RICOH Modification Bulletin

Model: Fax Unit type 200 (A639) Date			e: 31-Jul-97	No: 1	
Modified Article: Parts catalog correction			Prepared by: M.Horiike		
From: QAC 2nd Field Information Dept.					
Reason for	□ Parts catalog correction	☐ Vendo	or ch	ange 🔲 To n	neet standards
Modification:	☐ To facilitate assembly ☐ To improve		e reliability ()	
	☐ Part standardization	☐ Other

Model: Fax Unit Type 200/250 Date			e: 15-Apr-98	No: 2A		
Modified Article: Part catalog correction			Prepared by: K.Ugaeri			
From: QAC Field Information Dept.						
Reason for	□ Parts catalog correction	☐ Vend	lor ch	ange 🔲 To n	neet standards	
Modification:	☐ To facilitate assembly	e assembly				
	☐ Part standardization	Other

Model: Fax Unit Type 200 (A639) Date			e: 31-Aug-98	No: 3	
Modified Article: HDD Option			Prepared by: K.Ugaeri		
From: QAC Field Inf	ormation Dept.				
Reason for	☐ Parts catalog correction		cha	ange 🔲 To m	neet standards
Modification:	☐ To facilitate assembly	☐ To improve reliability () ☐ Other)
	☐ Part standardization

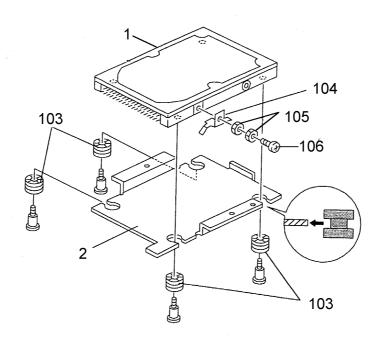
The current HDD unit has been discontinued by the supplier. A new HDD unit has been set up.

Old part	New part	Description	Int	Q'ty	Index	Page
number	number					
G6905723	H5157119	HDD – MK0803MAT		1→1	1	23
A1945817	A1945820	Bracket – HDD		1→1	2	23
04513006B		Tapping Screw – M3x6	0/0	6→2	101	23
	A1935843	Stepped Screw	≻as a set	0→4	102	23
	AA161125	Rubber Cushion		0→4	103	23
	A1935842	Grounding Plate – HDD		0→1	104	23
	07120030W	Nut – M3		0→1	105	23
	03130050B	Philips Pan Head Screw – M3x5		0→1	106	23

When an old HDD will be replaced with a new one, replace all parts in the above table.
